TOWN AND COUNTRY PLANNING ACT 1990
(DEVELOPMENT MANAGEMENT PROCEDURE) (ENGLAND) ORDER 2015
ARTICLE 18 CONSULTATION WITH HIGHWAY AUTHORITY

PROPOSAL: Detached 2-bedroom dwelling

LOCATION: 25 Sleetmoor Lane Somercotes Alfreton Derbyshire DE55 1RB

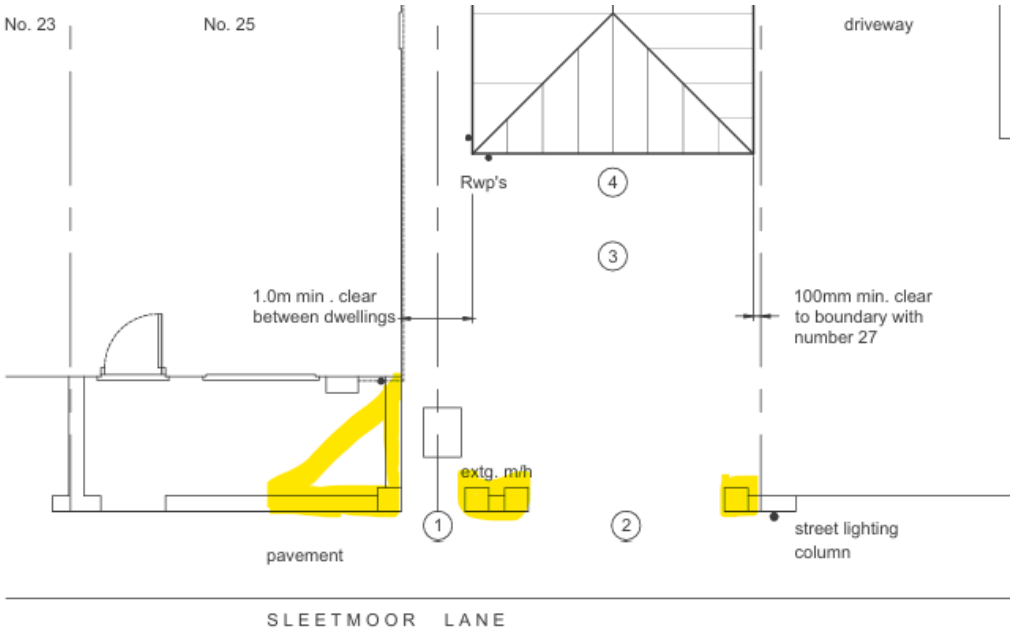
The proposed driveway would have sufficient width to accommodate 2 car parking spaces if the existing brick piers and walls which front the driveway (as highlighted on the following copy extract from the submitted block plan) are removed and if sufficient driveway depth is provided.

The applicant should submit a revised block plan to show removal of the brick piers and walls which would otherwise obstruct access to the two car parking spaces which can be provided on the driveway.

Car parking spaces should be 5.5m long by 2.4m wide. The proposed dwelling should therefore be set back further to the south of Sleetmoor Lane, by circa 1.6m, to allow provision of 2 no. 5.5m x 2.4m car parking spaces and a 0.9m wide path across the front face of the proposed dwelling to allow pedestrian access clear of the car parking spaces. One car parking space should be shown as being allocated to each of the existing and proposed dwellings.

2m x 2m pedestrian visibility splays. In this instance, there is insufficient space within the land under the applicant's ownership/control for a pedestrian splay to be provided on the western side of the driveway. However, there is space for such a splay to be provided on the eastern side of the driveway, subject to removal of part of the existing wall fronting the site. The revised block plan should show removal of the wall fronting the existing dwelling, as shown by the highlighted triangular area on the earlier copy extract from the submitted block plan, to allow provision of a 2m x 2m pedestrian splay to the east of the site access driveway.

The widened driveway will require the existing dropped kerb footway crossing to be widened to correspond to the full width of the driveway plus a new dropper kerb on the eastern side of the driveway. Details should be shown on the amended block plan.
